PUBLIC WORKS DEPARTMENT

Modification of or Addition to Improvement Standards and Details

Modification Number: 072505-1

ROADWAY AND TRENCH BACKFILL STANDARDS

MANHOLE BACKFILL DETAIL

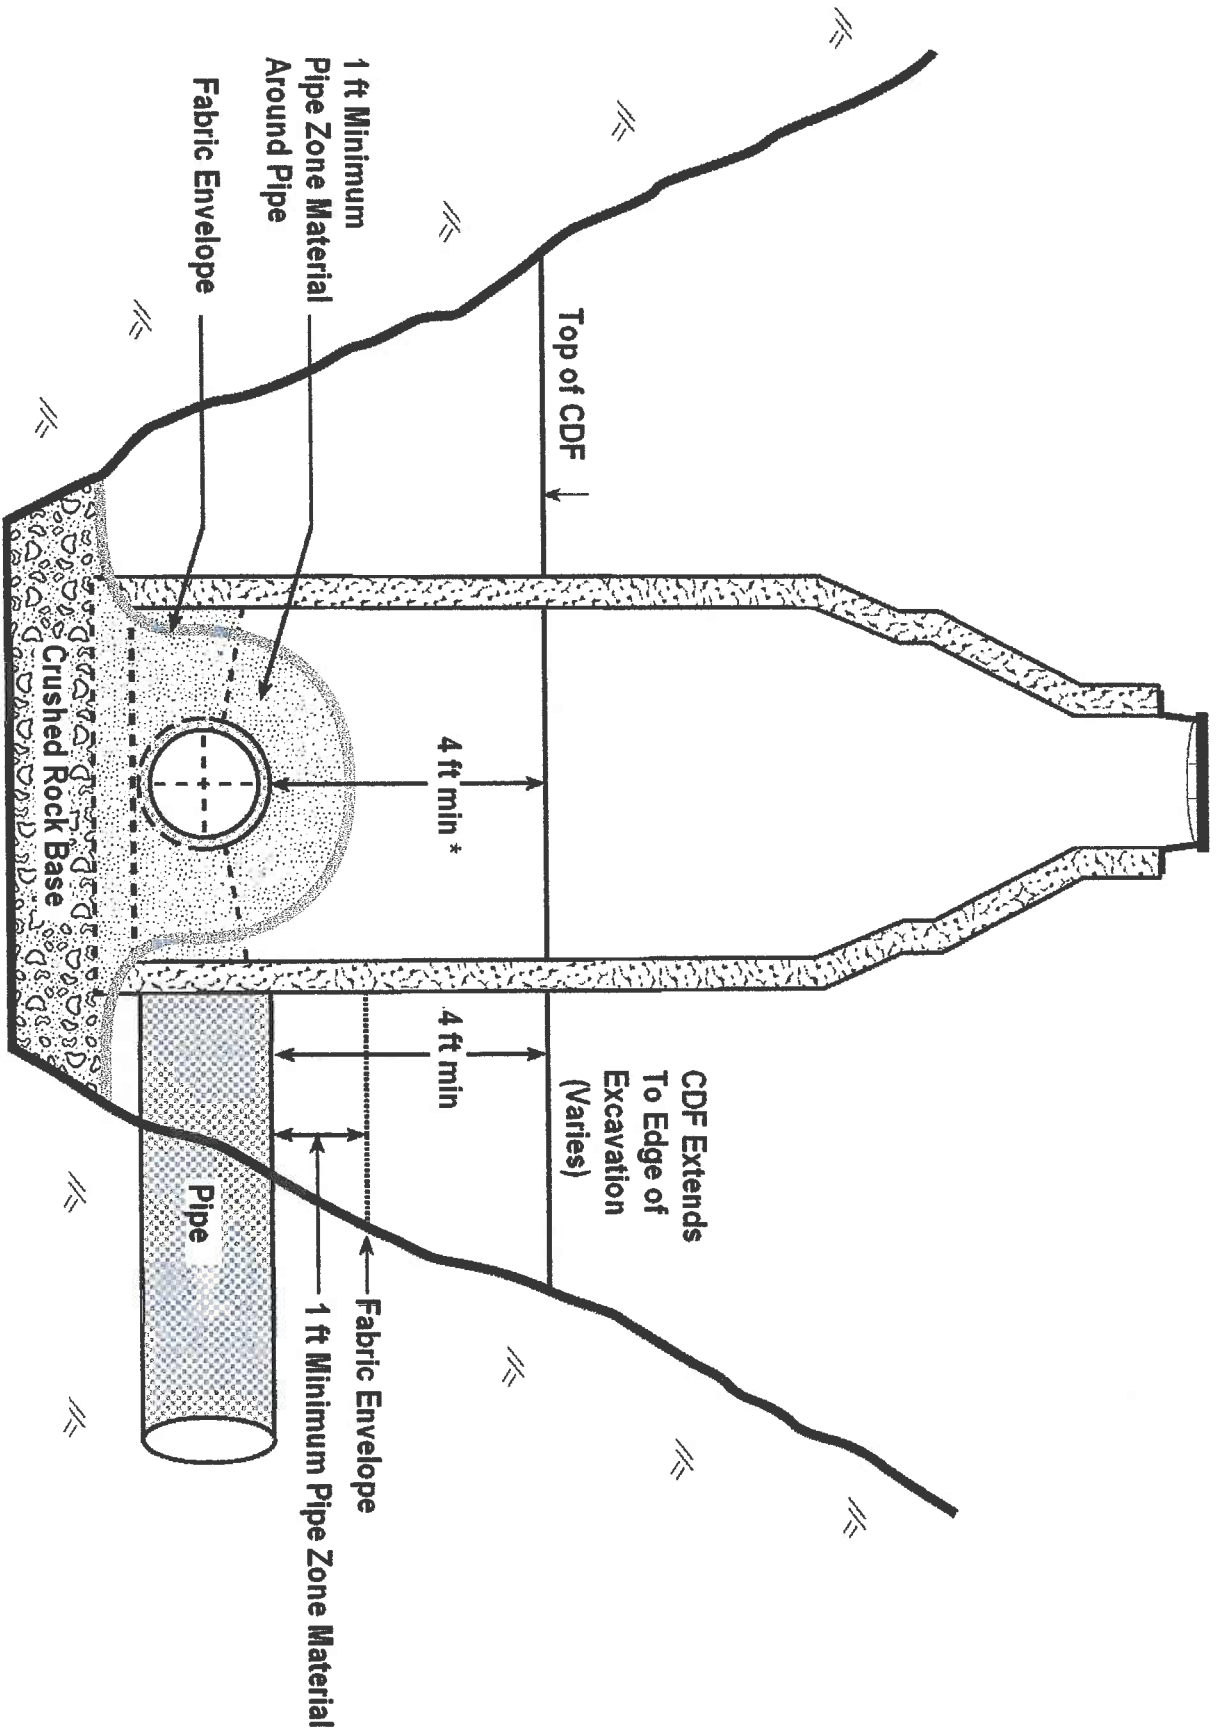
The pipe zone material surrounding pre-cast concrete manholes and extending out a minimum of 2 feet horizontally from the manhole barrel shall be backfilled with Type "C" material (CDF) up to a level at least 1 foot over the highest associated pipe, unless specified otherwise. The Type "C" backfill shall extend a minimum of 4 vertical feet (or to the base of the conical section of the manhole barrel) above the top of the lowest associated pipe. The material shall extend horizontally to the edges of the manhole excavation where adjoining trenches do not exist. In no case shall the Type "C" backfill material extend above the base of the conical section of the manhole barrel.

For Sacramento County installations, the Type "C" backfill shall be placed above the required pipe zone material (See Manhole Backfill Detail). The pipe zone material shall consist of crushed stone that meets Sacramento County standards extending laterally and vertically at least 12 inches around the pipe in all directions. The pipe zone material shall be covered with a Geotextile Fabric prior to placement of the required Type "C" backfill above it.

Drop manholes will be addressed on a case-by-case basis. See Manhole Backfill Detail.

* or the base of cone, whichever is less. Flattop manholes, CDF to be placed no higher than subgrade.
